Saltstone Disposal Facility: Determination of the probable maximum water table elevation

Design Check Instructions, Responses and Dispositions

Design Check Instructions for investigation of the probable maximum water table elevation near the Saltstone Disposal Facility (SDF).

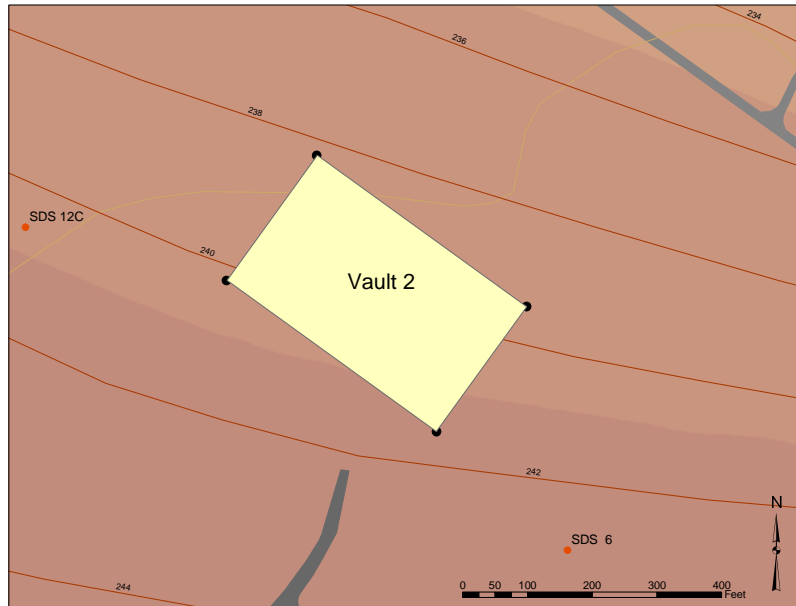
6. Check the values in Table 6 in **WSRC-TR-2005-00131 Rev 0.doc** against the figure on page 2 of the Design Check instructions to insure that the elevations listed for the corners of the proposed Vault 2 location have been accurately interpolated.

An independent interpolation was performed versus the referenced figure and the same values as listed in Table 6 were obtained.

Response: Comment acknowledged
